# BROKEN HILL OPERATIONS PTY LTD

9<sup>th</sup> November 2010

**Subject: Rasp Project Preferred Project Report**

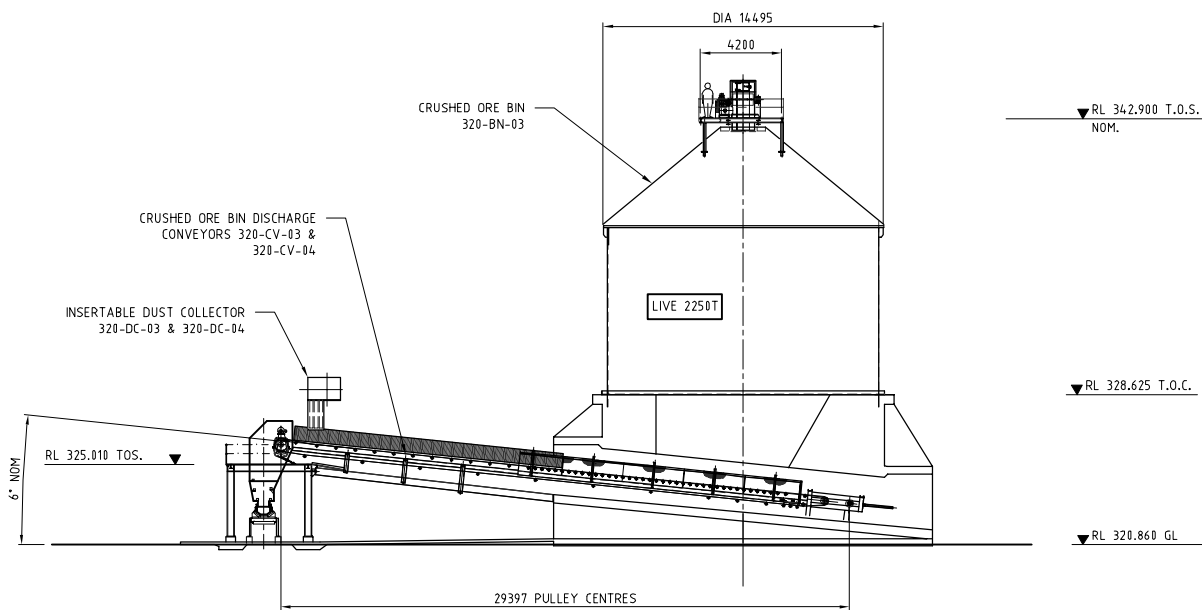
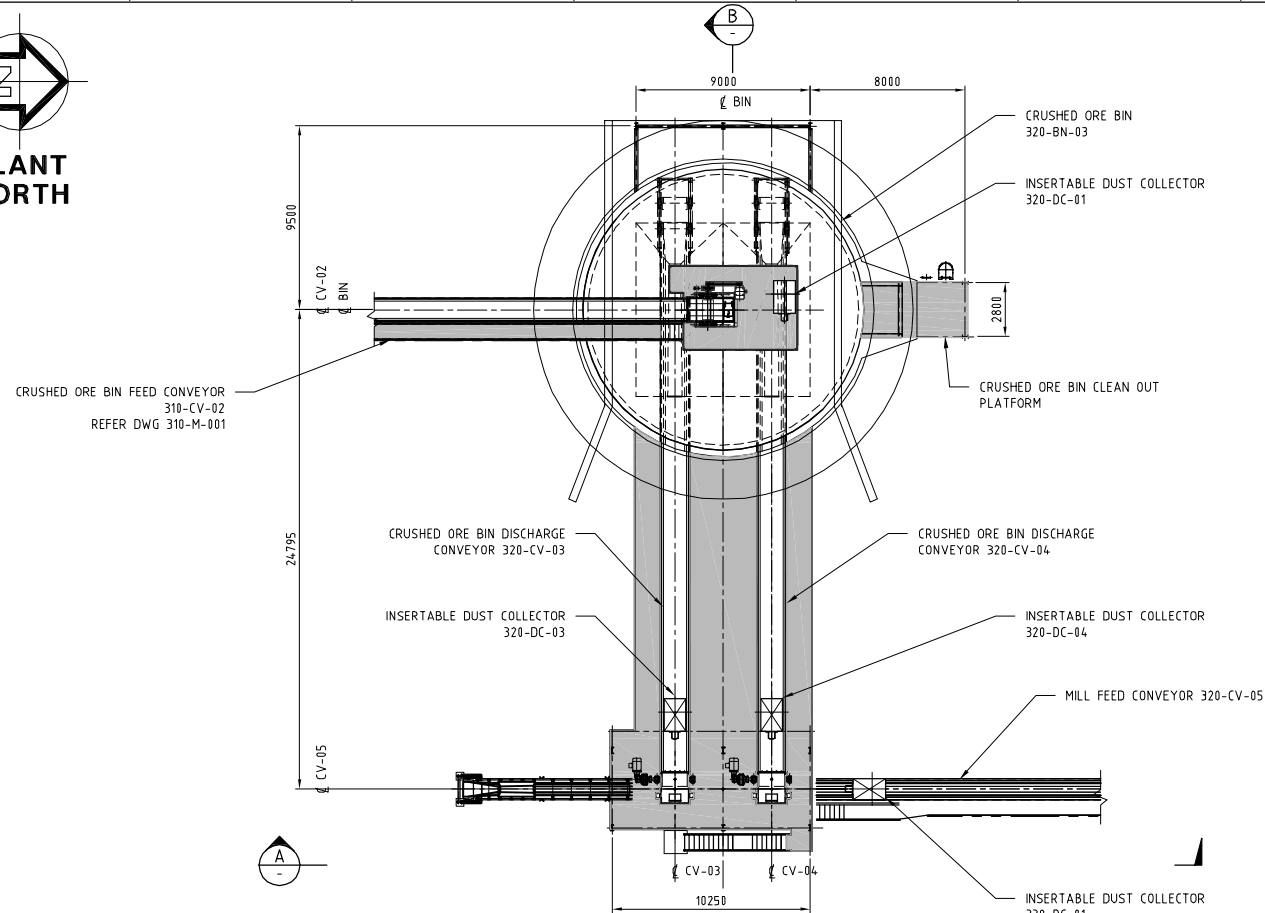
- Construction noise, in particular additional receptors (to A12) to be applied;
- Noise and vibration, as above dot point;
- Air Quality, current receptors are concentrated in Eyre Street and Crystal Street and do not adequately monitor activity at the proposed operations area.
- Community Health, comments as reflected in the GAWHS submission to the EAR remain the same, with an additional request that soil monitoring is made public – at least to the Lead Reference Group;
- Water resources, as per previous submission;
- Rainwater tanks, as per previous submission, and
- Effluent Reuse, as per previous submission.

The issue of construction noise limits and monitoring locations is moot given that predictions are well under the minimum threshold INP criteria of 35dB(A). It does not matter where or how many monitors are used during construction since levels are predicted to be relatively low and below background noise levels, refer below noise contours for construction.

## STORAGE AND HANDLING AREA - PLAN

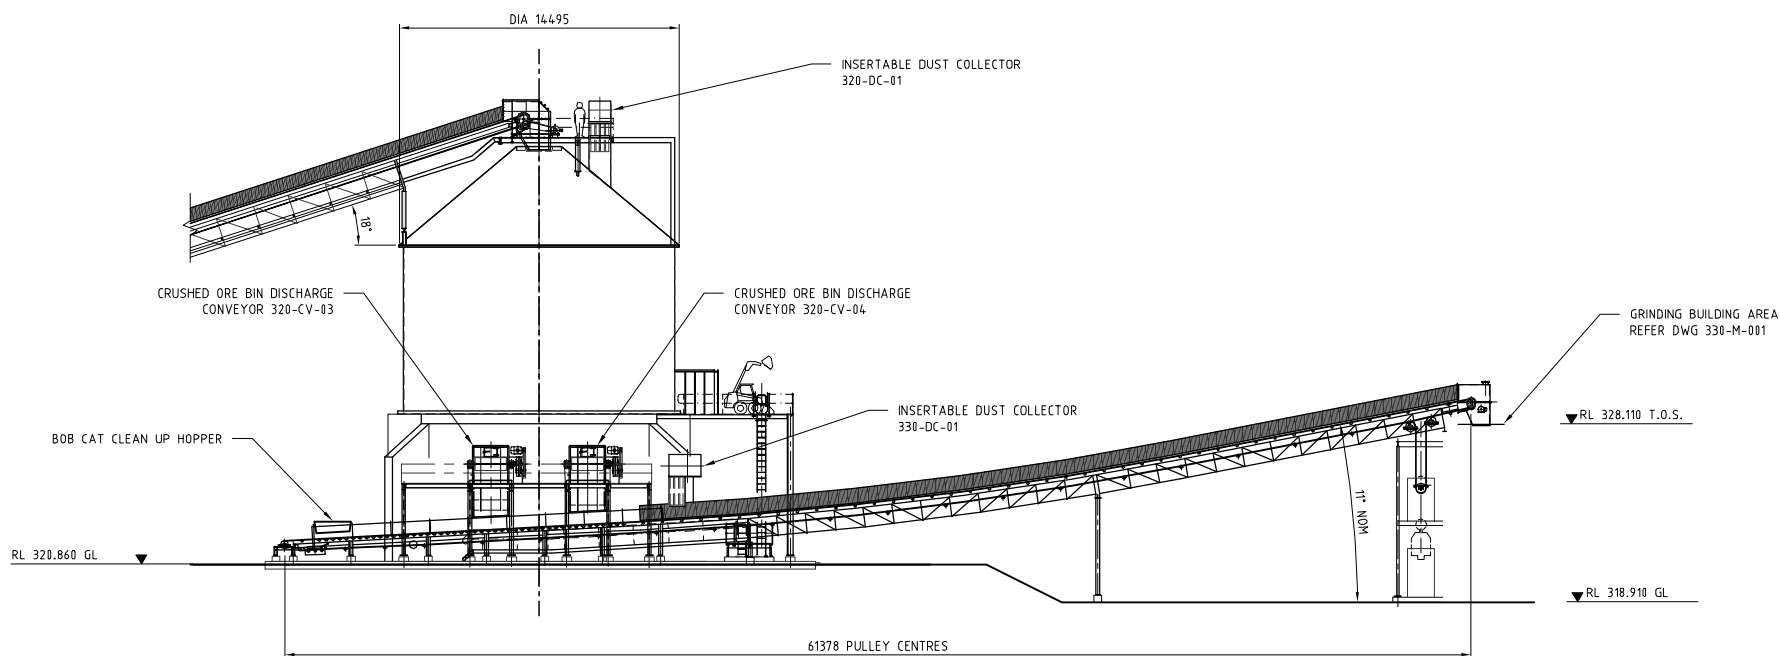
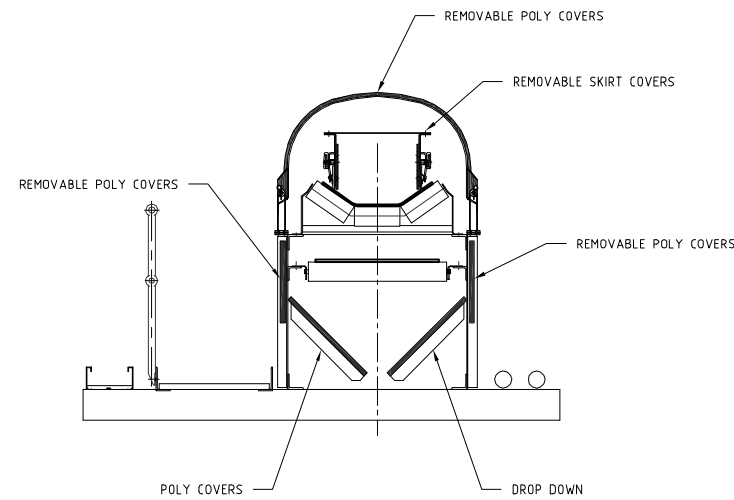
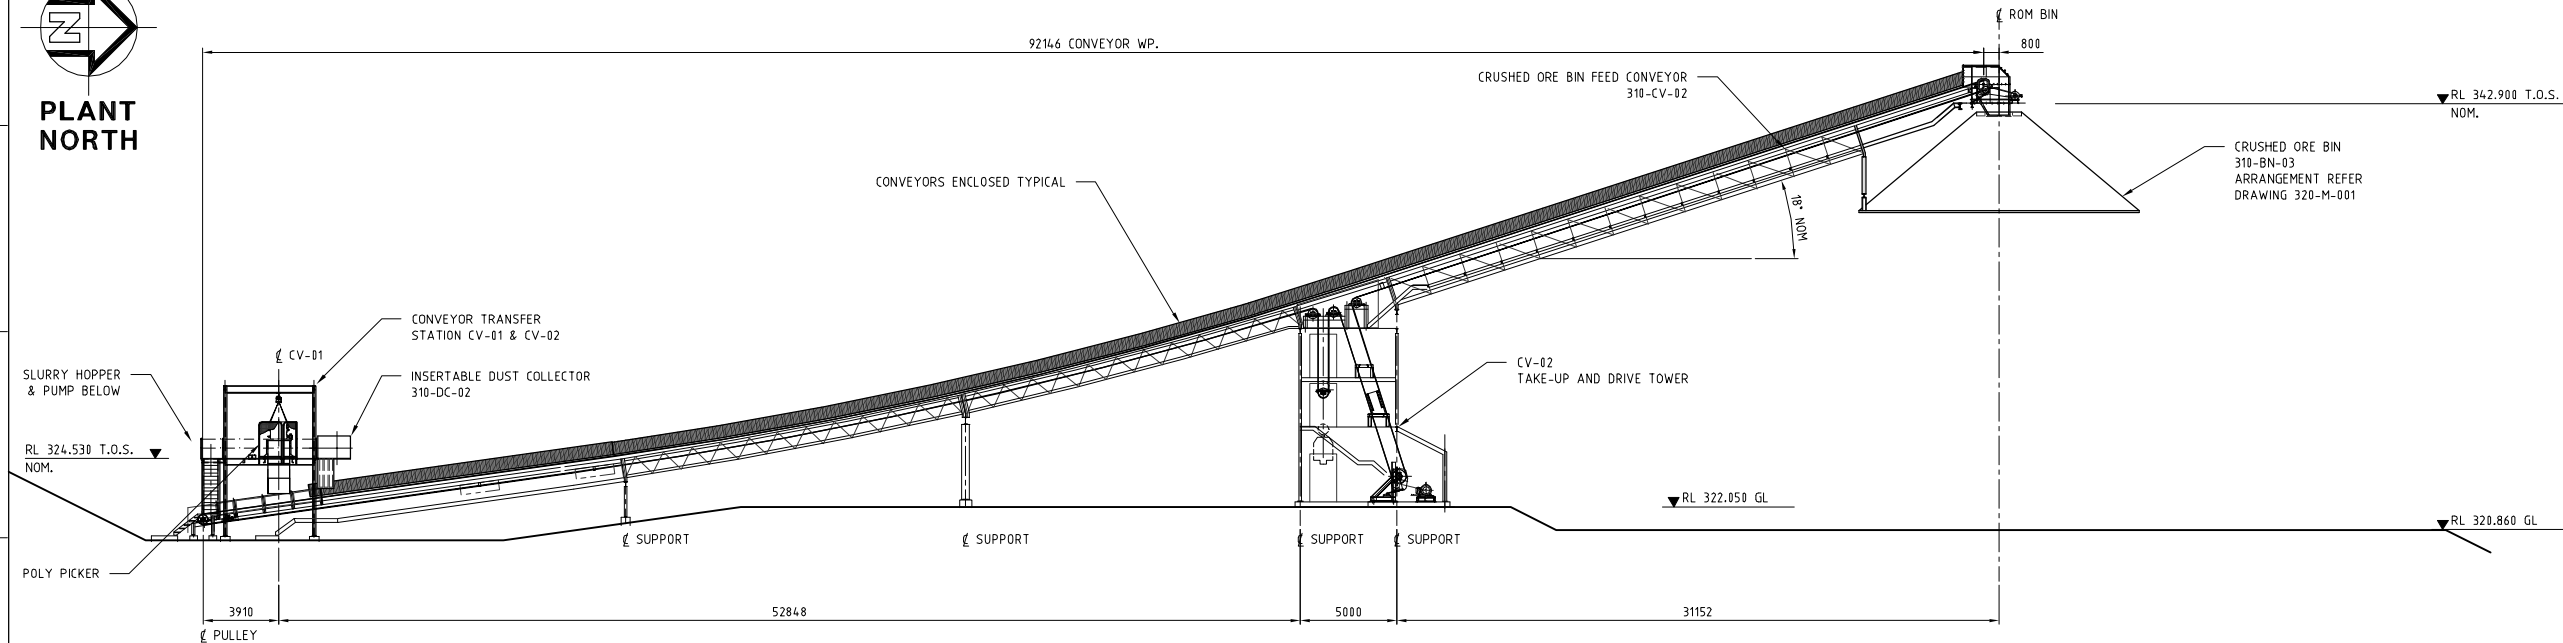
- The processing enclosure must be designed to operate under negative pressure at all times.

*Crushed ore will be transported to the enclosed Crushed Ore Bin via a fully enclosed conveyor. The drawings 30121-310-M-002 - Rev E and 30121-320-M-001 – Rev E illustrate the conveyor.*

BHOP has been informed by the design engineers that the enclosure as provided together with the operation of the baghouse will form a negative pressure environment when in operation. Therefore BHOP agrees that during operation the crushing enclosure will operate under negative pressure.

*The extremely high air flow into the bag house at 9700 L/sec results in a negative pressure being developed within the enclosed crusher building.*

CRUSHING AREA - SECTIONS

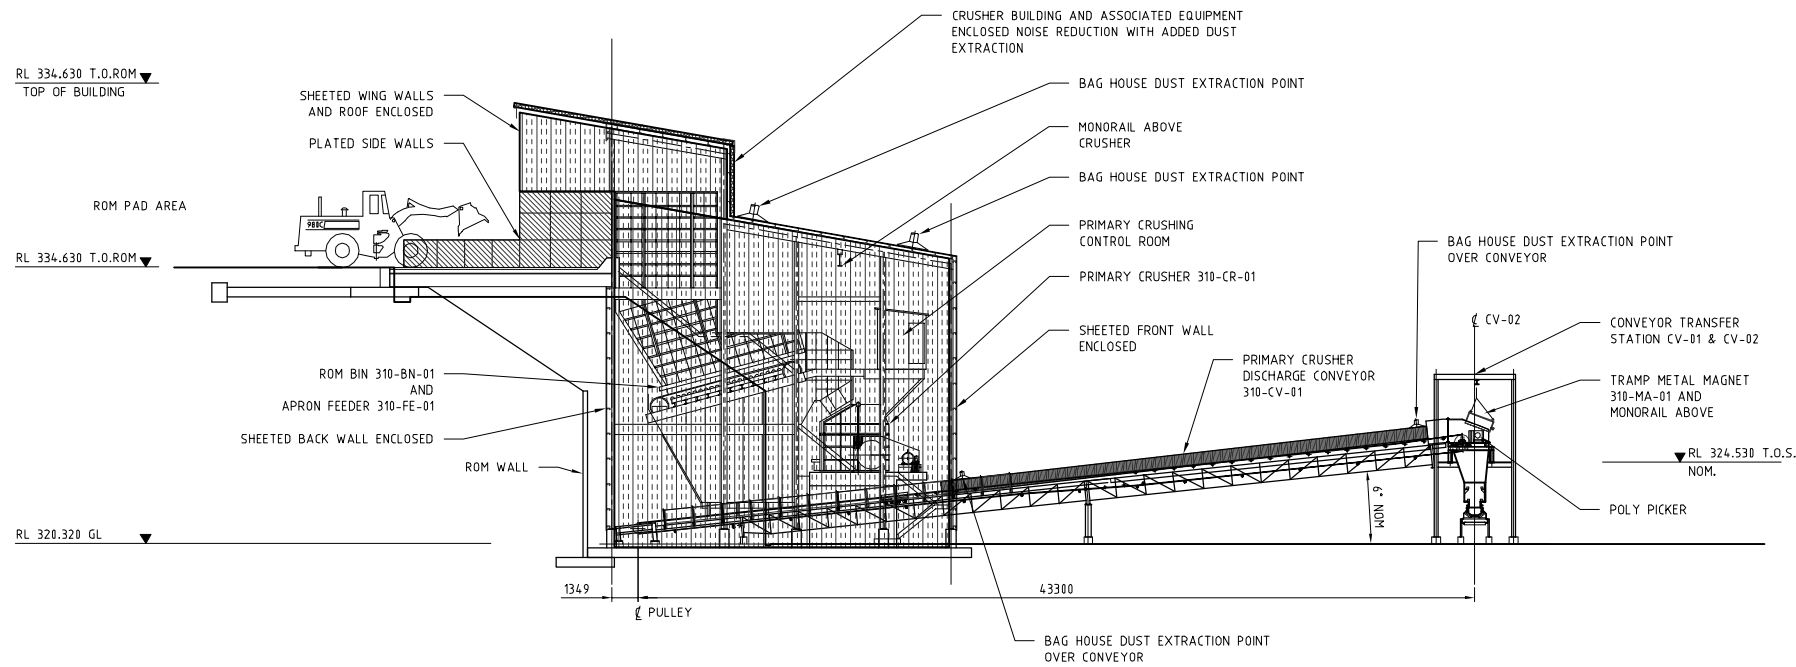
- The processing enclosure and associated emission controls must be constructed and operated in such a manner, as to ensure visible fugitive emissions from the enclosure do not occur.

*“Please find attached current drawings for the design of the primary crushing unit. The crusher will be contained within a building structure which is fully enclosed from the floor level to the roof as shown in attached drawings 30121-310-SK-002 - Rev B and 30121-310-M-002 – Rev E. The roof, bottom panels to the floor and the front and back sheeting have been added to provide this enclosed structure.*

*As can be seen from drawing 30121-310-M-002 – Rev E, four dust extraction points are currently proposed reporting to the bag house, including two points over the conveyor. The manufacturer's manual states that the control efficiency rate for this bag house is 99.5%”*
